## **1.2 General Plant Description**

The information in this section of the reference ABWR DCD, including all subsections, tables, and figures, as modified by the STP Nuclear Operating Company Application to Amend the Design Certification rule for the U.S. Advanced Boiling Water Reactor (ABWR), "ABWR STP Aircraft Impact Assessment (AIA) Amendment Revision 3," dated September 23, 2010 is incorporated by reference with the following departures and supplements.

Figure 1.2-1 Site Plan

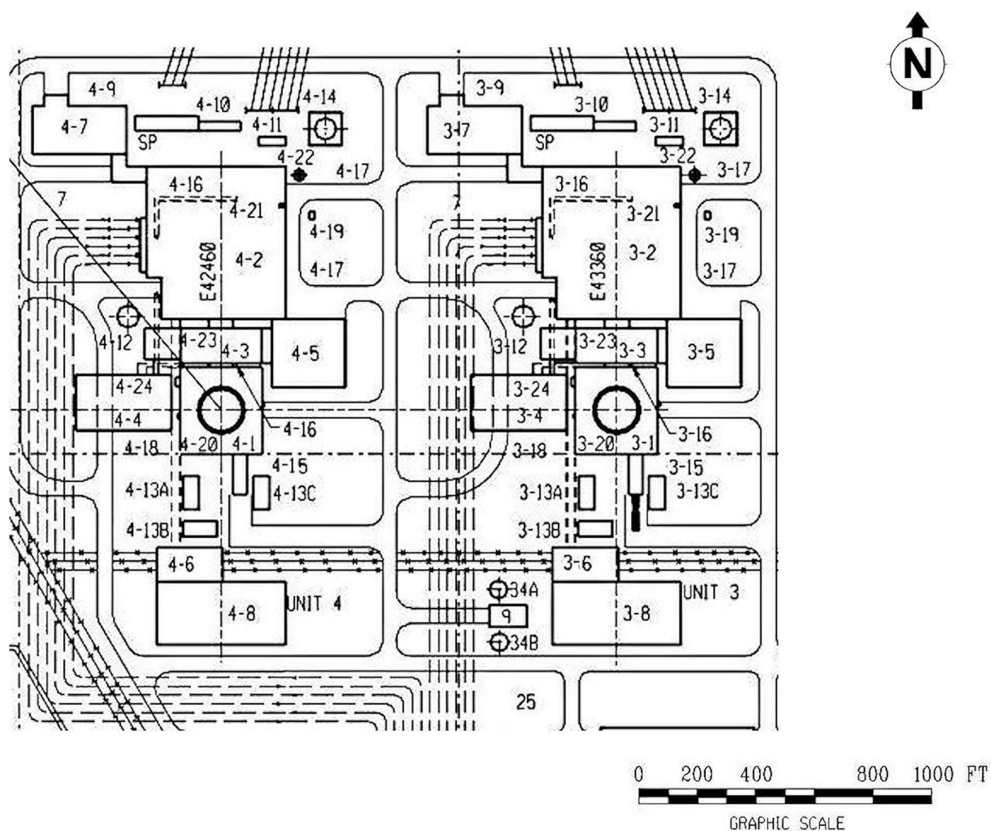
STP DEP 1.1-2 (Figure 1.2-1)
